2. Name of Operator EOG RESOURCES INCORPORATED

8. Well Name and No. ROSS DRAW 17 FED COM/703H

9. API Well No. 30-015-47730

EOG respectfully requests an amendment to our approved APD for this well to reflect the following changes:

Revised Wellbore

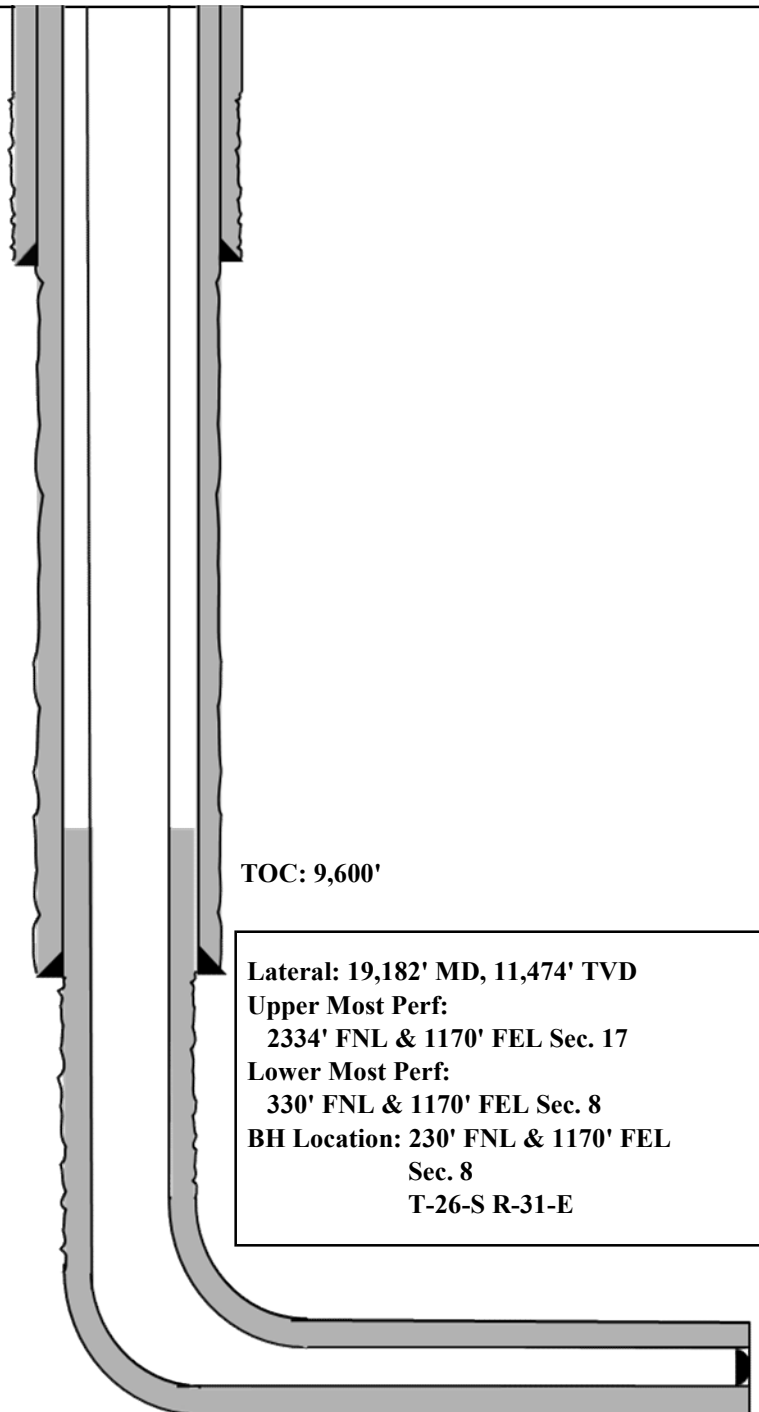
Update casing and cement program to current design.

Bit Size: 12-1/4"
9-5/8", 36#, J-55, LTC,
@ 0' - 1,310'

Bit Size: 8-3/4"
7-5/8", 29.7#, HCP-110, FXL,
@ 0' - 10,100'

Bit Size: 6-3/4"
5-1/2", 20#, P110-EC, DWC/C IS MS,
@ 0' - 9,600'

5-1/2", 20#, P110-EC, Vam Sprint SF,
@ 9,600' - 10,100'

5-1/2", 20#, P110-EC, DWC/C IS MS,
@ 10,100' - 19,182'

Figure 1: Cameron TA Plug and Offline Adapter Schematic

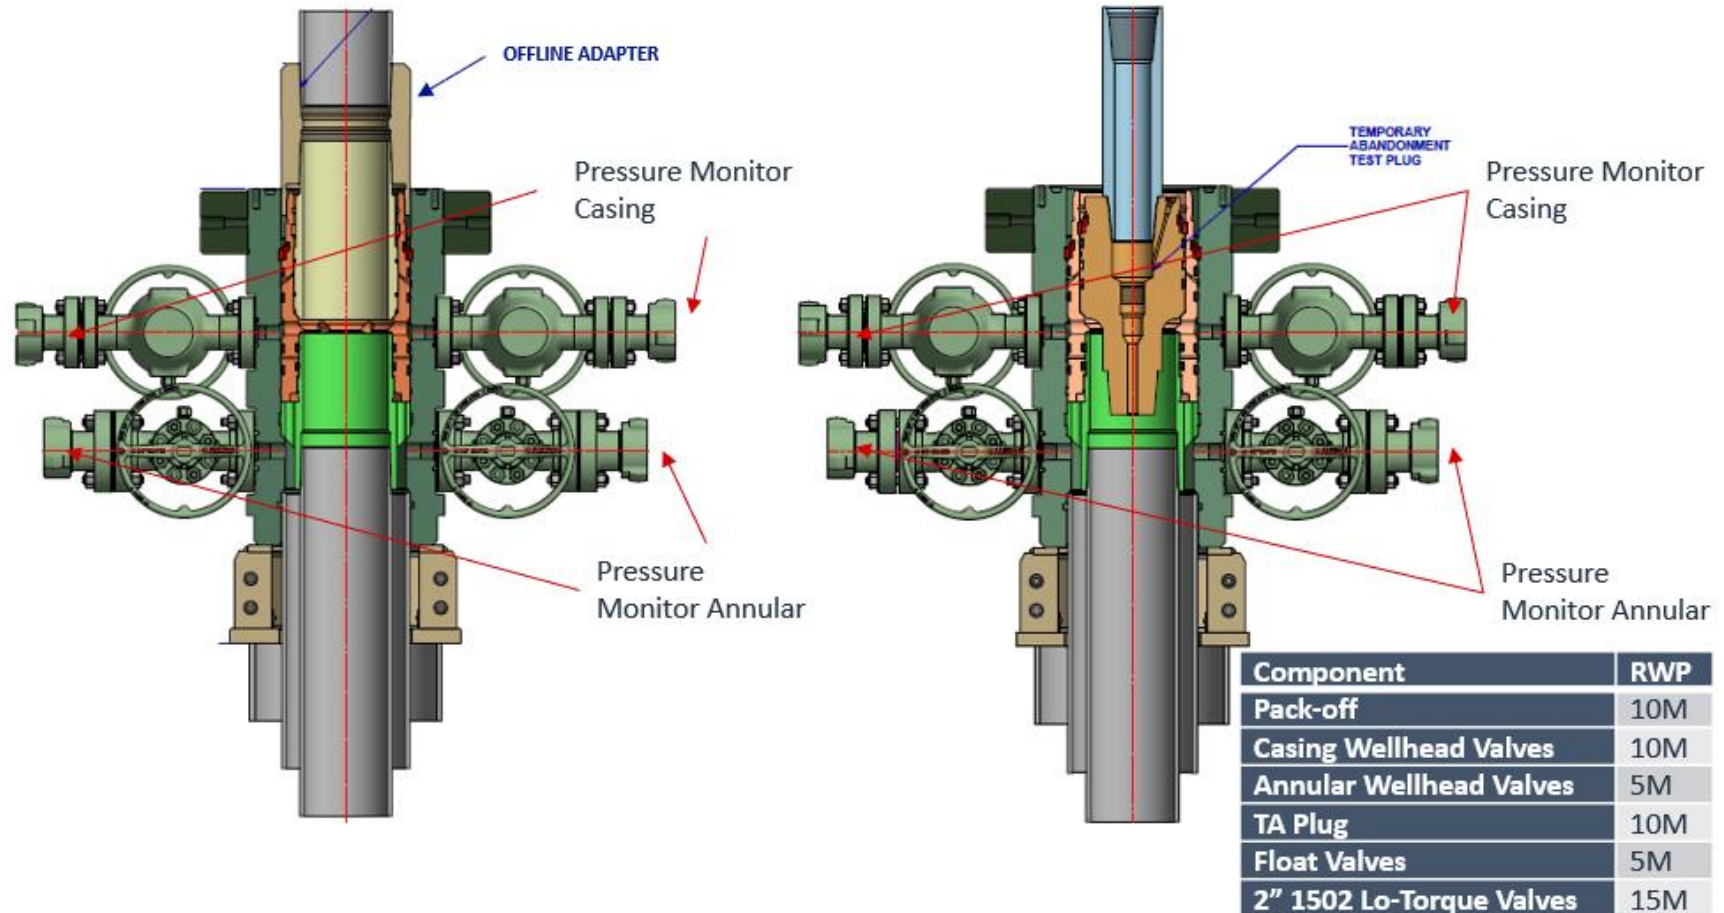
- c. Return line schematics can be seen in Figure 3.
10. Remove TA Plug from the casing.
11. Install offline cement tool.
 - a. Current offline cement tool schematics can be seen in Figure 1 (Cameron) and Figure 2 (Cactus).

Figure 4: Rig Placement Diagram

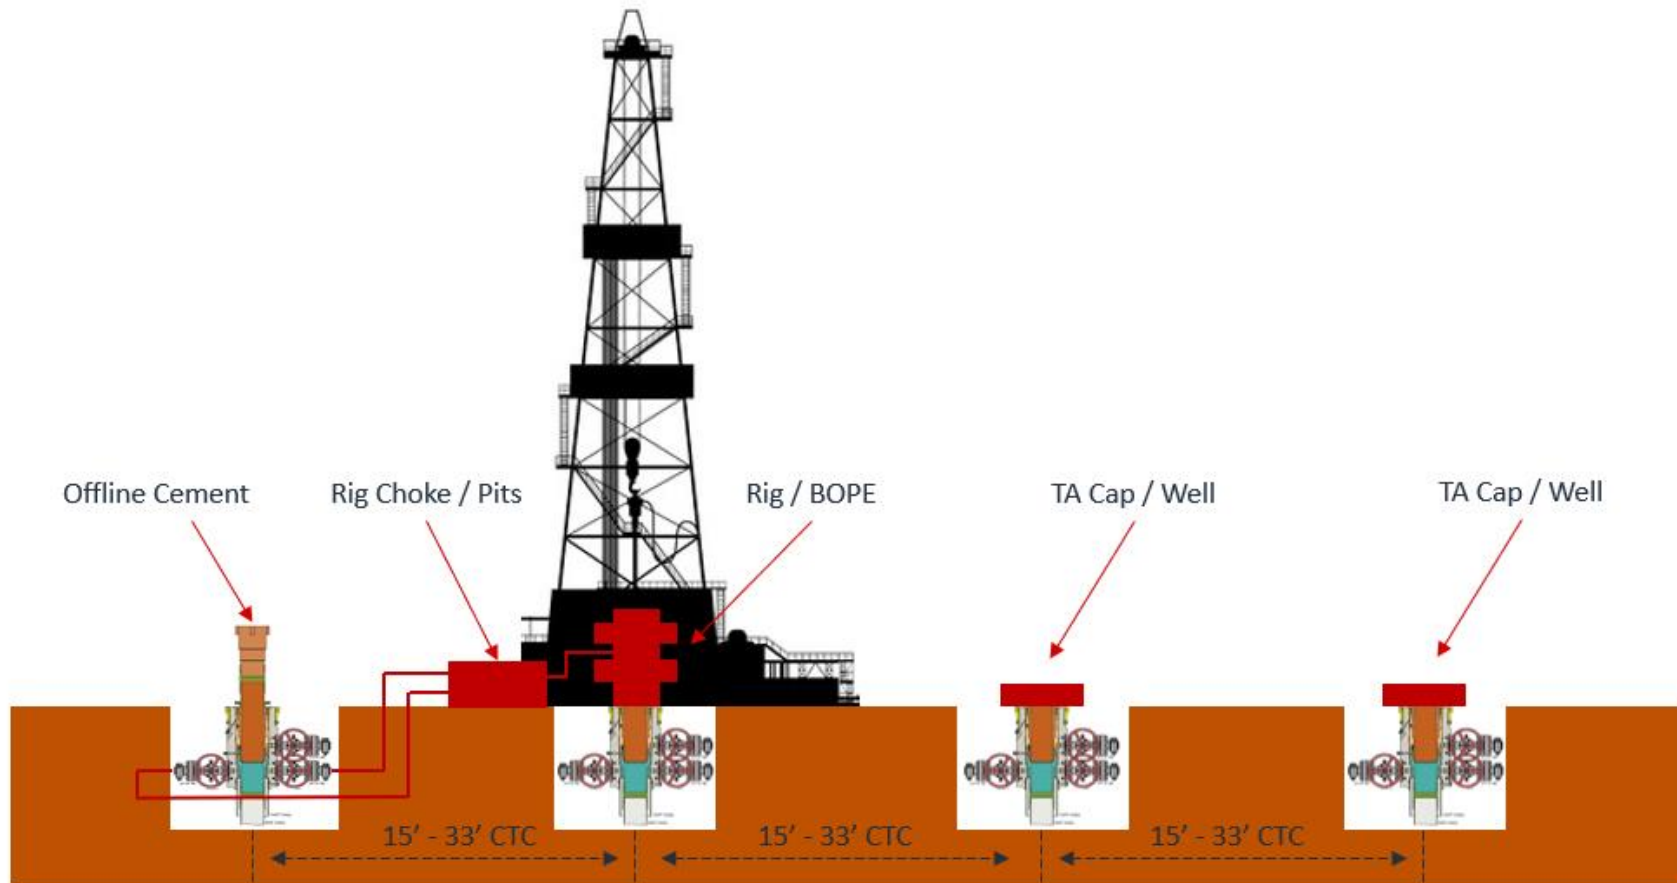
- e. Diagram for rig positioning relative to offline cementing can be seen in Figure 4.
9. Rig up return lines to take returns from wellhead to pits and rig choke.
